Subject: Issuance of Amendment No. 42 to Facility Operating License NPF-35 and Amendment No. 35 to Facility Operating License NPF-52-Catawba Nuclear Station, Units 1 and 2 (TACS 67115/67116)

AMENDMENT NO. 35 TO FACILITY OPERATING LICENSE NPF-52 - Catawba Nuclear Station, Unit 2
AMENDMENT NO. 42 TO FACILITY OPERATING LICENSE NPF-35 - Catawba Nuclear Station, Unit 1

SAFETY EVALUATION BY THE OFFICE OF NUCLEAR REACTOR REGULATION
RELATED TO AMENDMENT NO. 42 TO FACILITY OPERATING LICENSE NPF-35
AND AMENDMENT NO. 35 TO FACILITY OPERATING LICENSE NPF-52

CATAWBA NUCLEAR STATION, UNITS 1 and 2

FIGURE 3.2-3
REACTOR COOLANT SYSTEM TOTAL FLOW RATE VERSUS R - FOUR LOOPS IN OPERATION

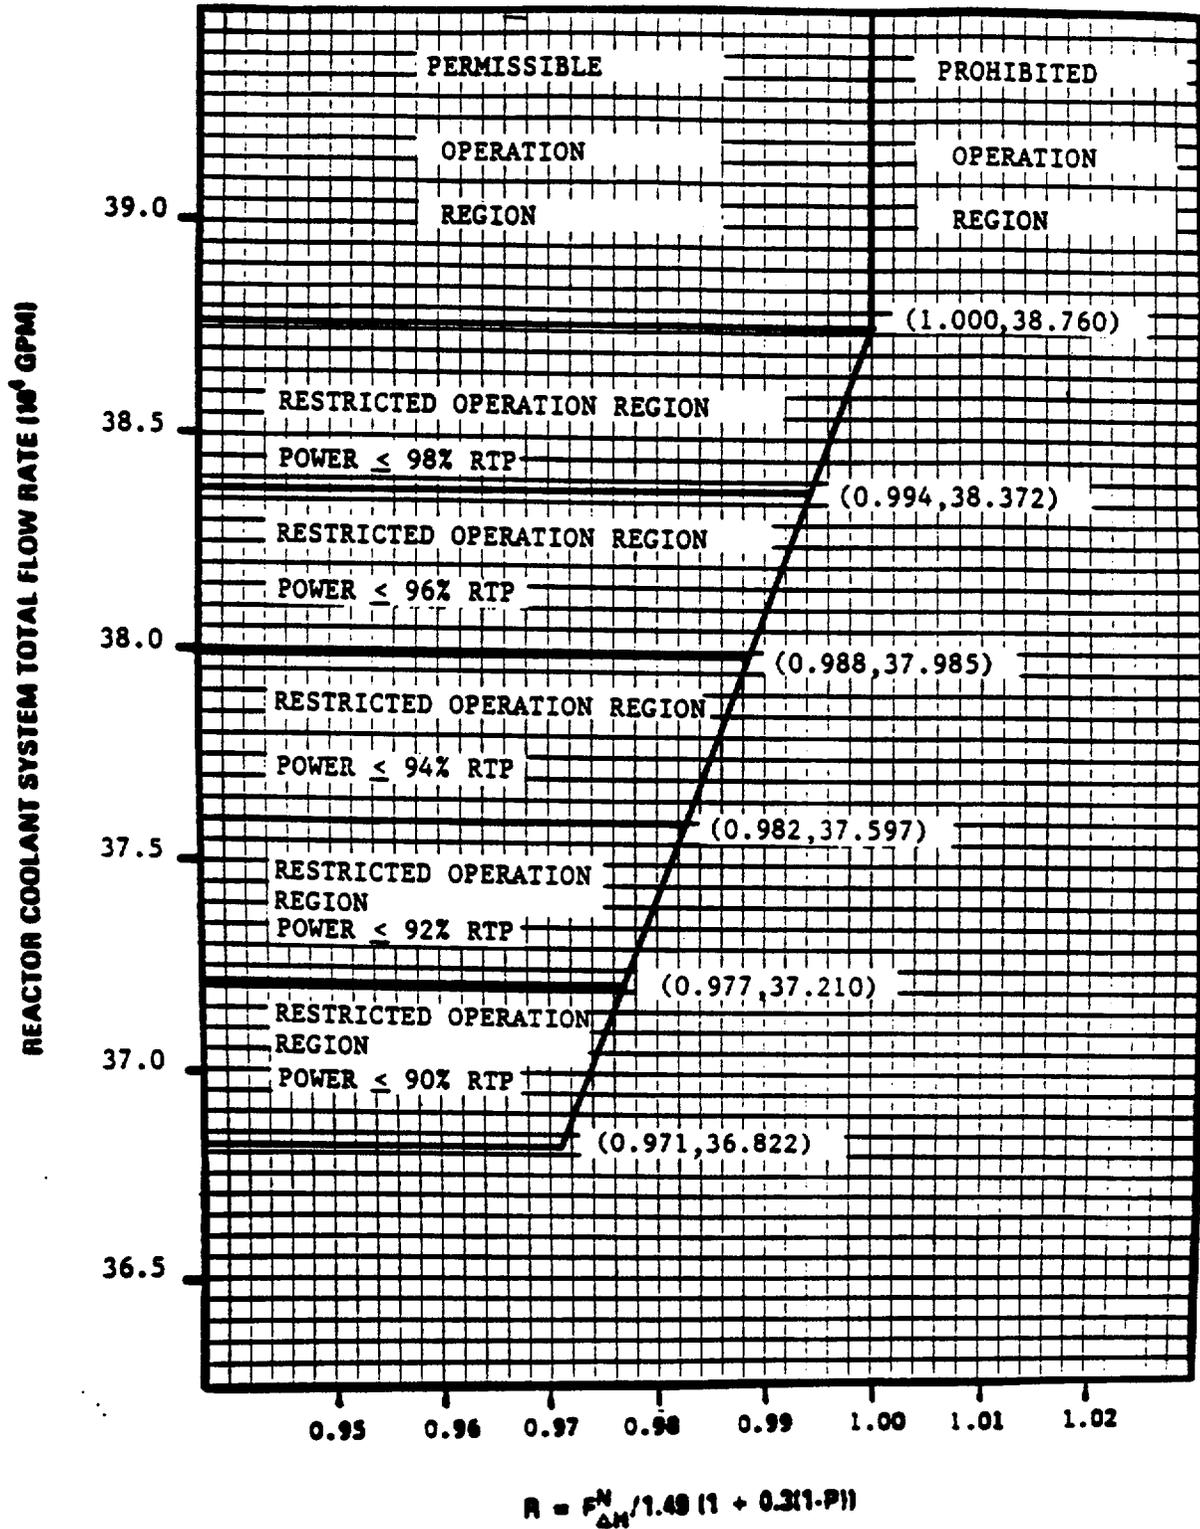
- a. With the combination of Reactor Coolant System total flow rate and R within the region of restricted operation (flow rate less than 387,600 gpm), within 6 hours reduce the Power Range Neutron Flux-High Trip Setpoint to below the nominal setpoint by the same amount (% RTP) as the power reduction required by Figure 3.2-3.

By letter dated February 10, 1988, Duke Power Company, et al., (the licensee) proposed amendments to the operating licenses for Catawba Nuclear Station, Units 1 and 2, which would change Technical Specification (TS) Table 2.2-1, TS 3/4.2.3, and TS Figure 3.2-3 to reduce the required Reactor Coolant System (RCS) total flow from 396,100 gpm to 387,600 gpm.

All applicable FSAR postulated accidents and transients that have been analyzed used an assumed flow which is equal to, or conservative with respect to, the proposed TS flow of 387,600 gpm.

Certain Catawba FSAR Chapter 15 transients, those using the Improved Thermal Design Procedure (ITDP), are analyzed with a nominal flow rate of 387,600 gpm as outlined in the above submittal. The appropriate flow rate assumption for the Catawba FSAR Chapter 15 transients not using ITDP is the proposed TS

minimum measured flow, 387,600 gpm, adjusted down by the flow uncertainty, 2.2%, to give 379,073 gpm. All of these transients are currently analyzed, as outlined in the above submittal, with flow rates less than this adjusted value and are therefore conservative.

The thermal hydraulic design analyses for the latest reload cores, Catawba 1 Cycle 3 and Catawba 2 Cycle 2, used the minimum measured flow of 387,600 gpm. It can be seen from this and from the preceding discussion of FSAR Chapter 15 analyses, that all applicable steady-state and transient core thermal-hydraulic analyses have been performed with flows equal to, or conservative with respect to, the proposed TS minimum measured flow.

On the basis of its review, the staff finds that the revision to the TSs will not adversely impact the accident analyses documented in Sections 6.2.1 and 15 of the FSAR nor the steady-state thermal-hydraulic reload design analyses discussed in Section 4.4 of the FSAR. Therefore, the changes to TS Table 2.2-1, TS 3/4.2.3, and TS Figure 3.2-3 are acceptable.
